DISCRETIONARY REVIEW ABBREVIATED ANALYSIS

HEARING DATE: SEPTEMBER 23, 2021

Record No.: 2021-000269DRP-02
Project Address: 3669 21ST Street
Permit Applications: 2020.1228.1772 and 2020.1226.1735
Zoning: RH-1 [Residential House, One-Family]
40-X Height and Bulk District
Block/Lot: 3620 / 054
Project Sponsor: John Maniscalco
442 Grove St.
San Francisco, CA 94102
Staff Contact: David Winslow – (628) 652-7335
david.winslow@sfgov.org

A3.0-11

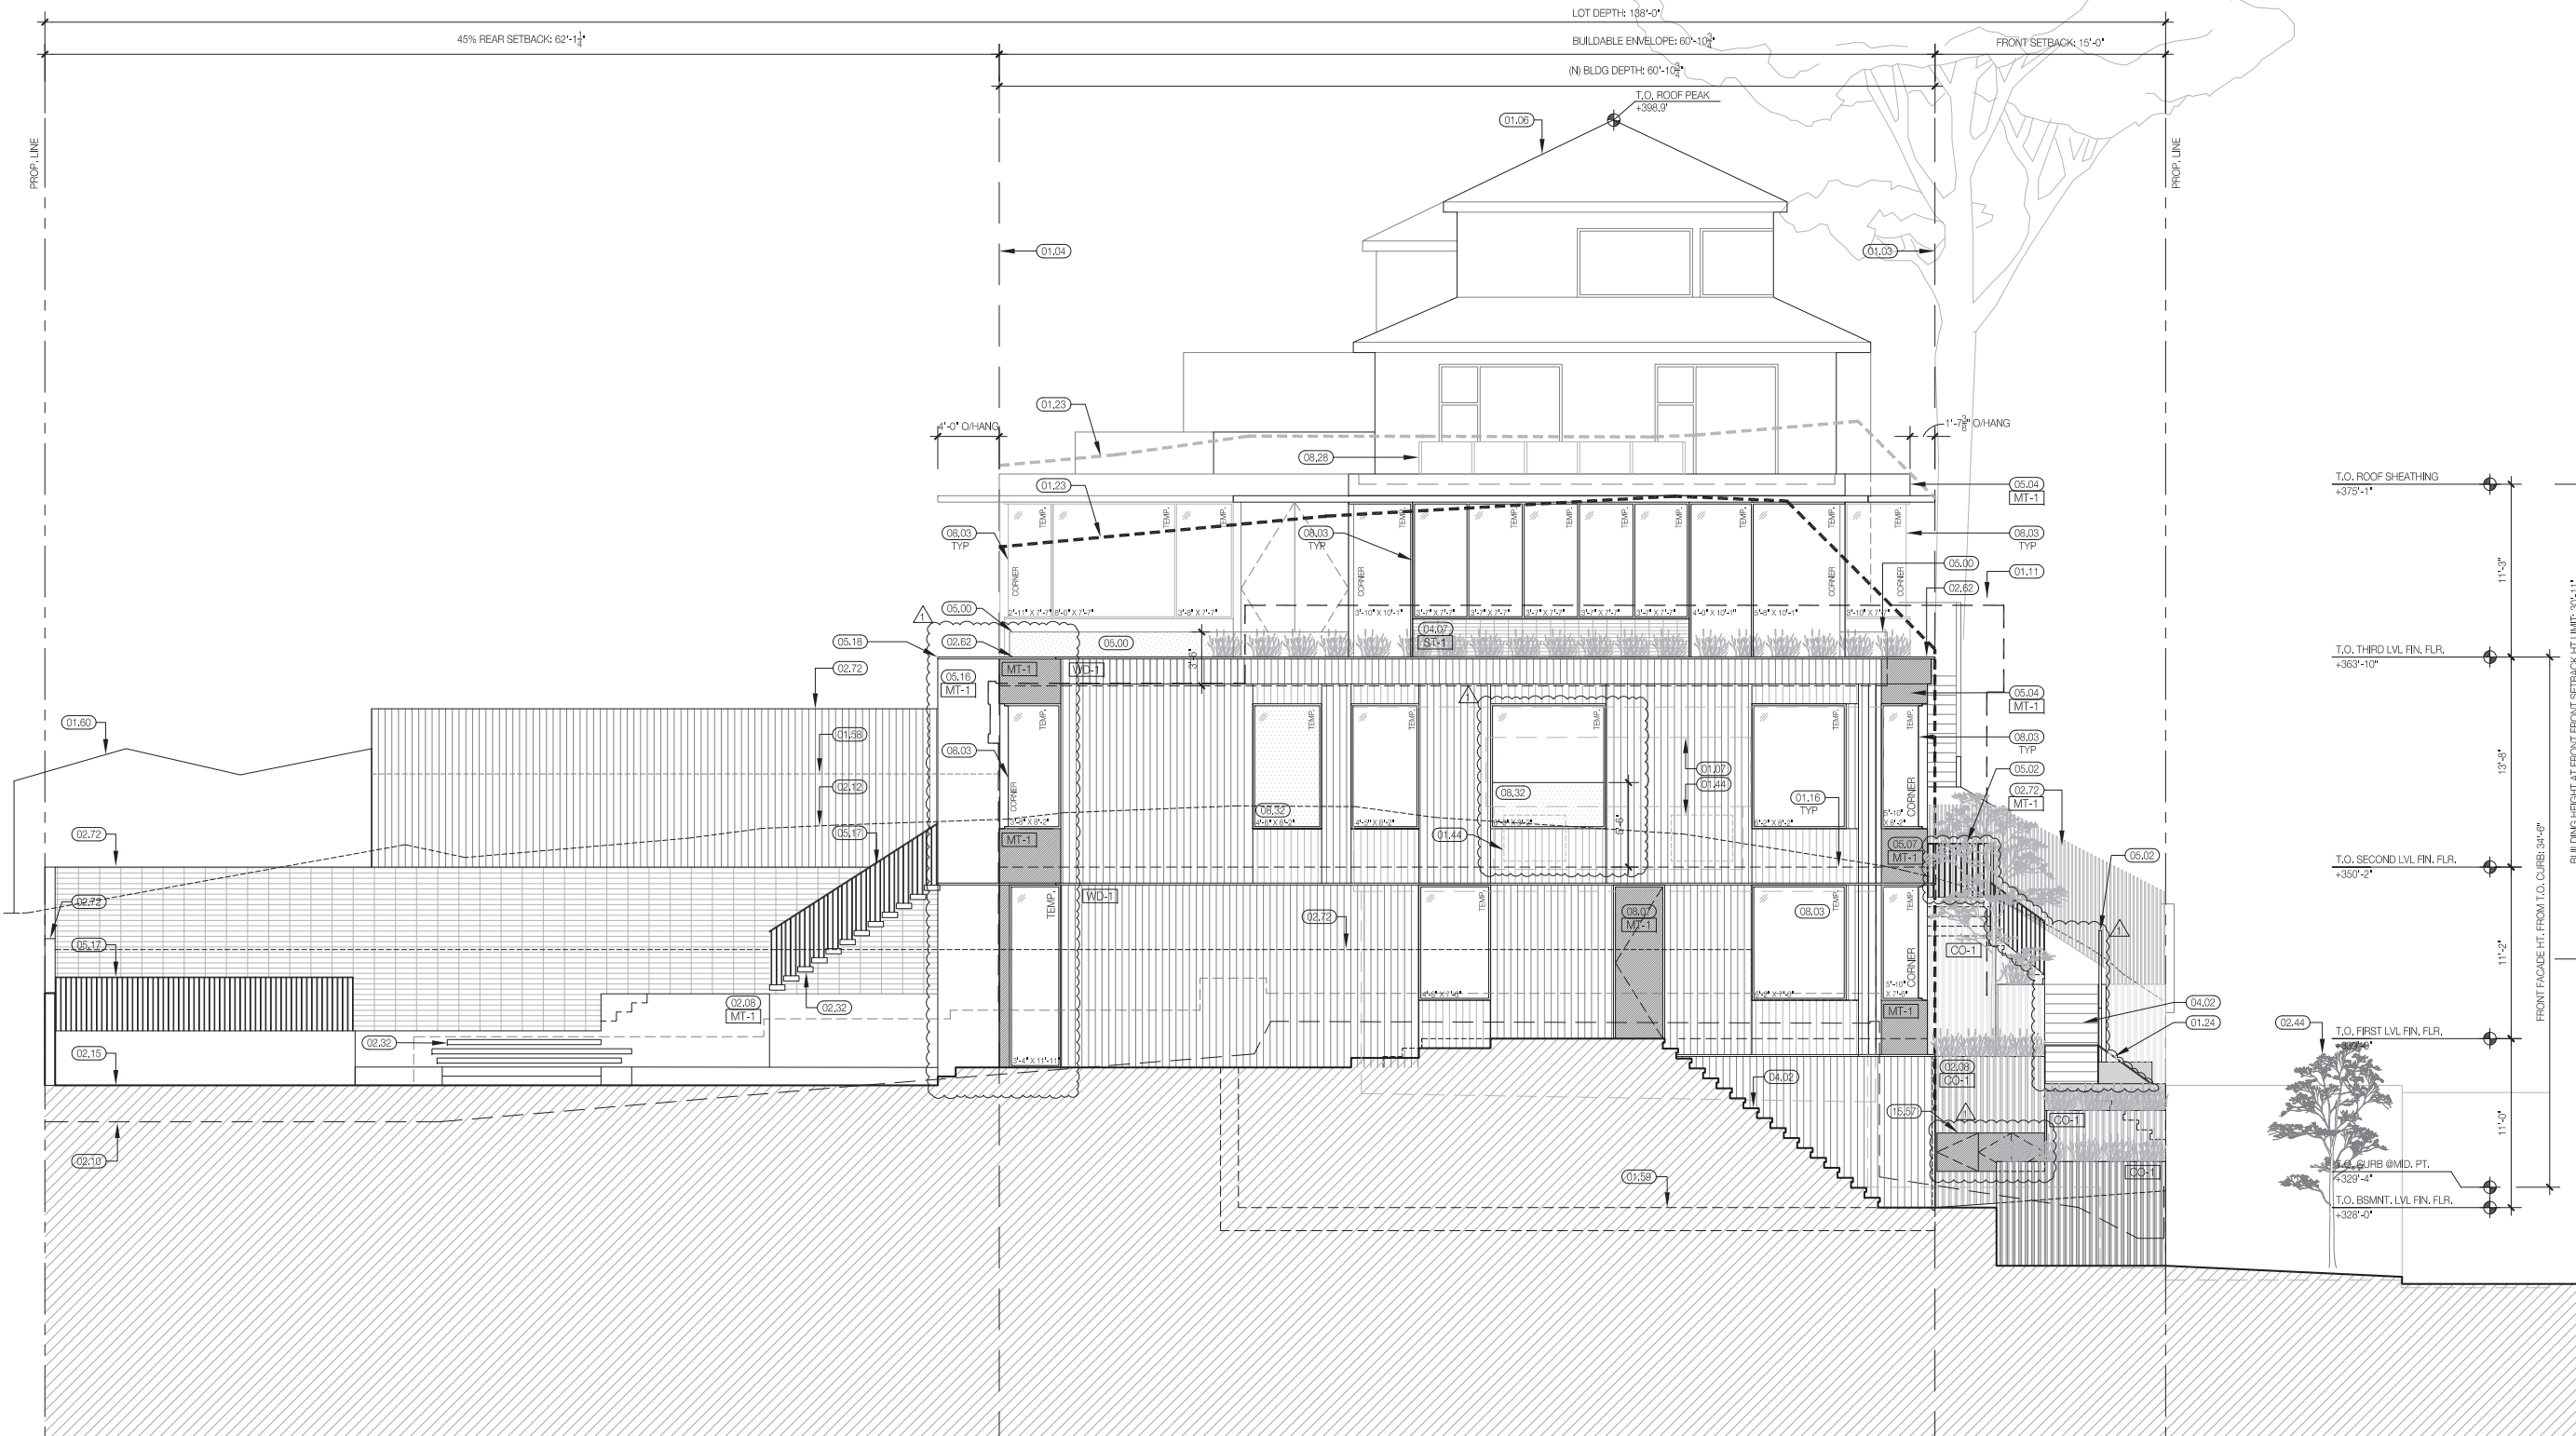
“Articulate buildings to minimize impact on light and privacy.” Specifically, loss of light to side facing windows and loss of privacy from the roof deck at the southeast corner of the proposed building.

1. Step back the upper floor to allow direct light to come in during late afternoon hours.
2. Use privacy glass in the windows facing the bathroom and studio.
3. Provide screening on the deck or along the fence line.

The project sponsor has modified the east facing windows with etched glass to address privacy concerns vis-a-vis the adjacent downhill neighbor's windows. (Sheet A3.0-11).
